Stage 06: Final CUSC Modification Report

CAP189 Standard Gas Insulated Switchgear (GIS) Ownership Boundaries

This proposal seeks to modify the CUSC such that a User requesting a connection to the National Electricity Transmission System (NETS), via a GIS substation, will be able to elect from a choice of two standard ownership boundaries.

DIAGRAM SHOWING ELECTRICAL BOUNDARIES FOR GAS INSULATED SWITCHGEAR

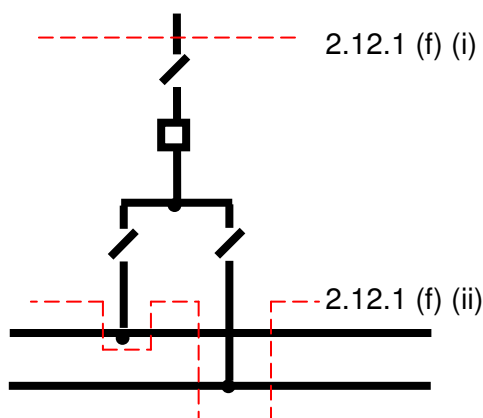
7.4 It was identified that the proposed legal drafting will, in most cases, result in a boundary within the GIS (between the circuit-breaker and the circuit disconnecter) and that this was not the intention of the Workgroup. The discussions in the Workgroup related to the boundary being at the cable termination and therefore, UK Power Networks have proposed a text change to cover both scenarios (e.g. where there is a circuit disconnecter and where there is no circuit disconnecter).

2.12.1 Subject to the **Transfer Scheme** or any contrary agreement in any **Bilateral Agreement** or any other agreement the division of ownership of **Plant** and **Apparatus** shall be at the electrical boundary, such boundary to be determined in accordance with the following principles:

DIAGRAM SHOWING ELECTRICAL BOUNDARIES FOR GAS INSULATED SWITCHGEAR

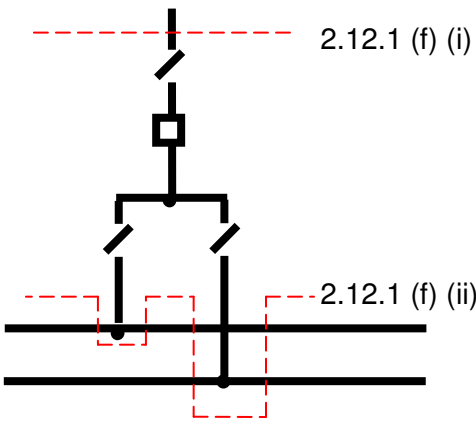
- 3.35 Following the issue identified by UK Power Networks with the legal drafting and the recommendation from the CUSC Modification Panel for CAP189 to go through the 'Send Back' process, the following discussions have taken place.
- 3.36 National Grid as Code Administrator has contacted each of the Workgroup members to discuss the changes suggested by UK Power Networks. Following this discussion, revised legal text has been drafted (see Annex 9).

2.12.1 Subject to the **Transfer Scheme** or any contrary agreement in any **Bilateral Agreement** or any other agreement the division of ownership of **Plant** and **Apparatus** shall be at the electrical boundary, such boundary to be determined in accordance with the following principles:
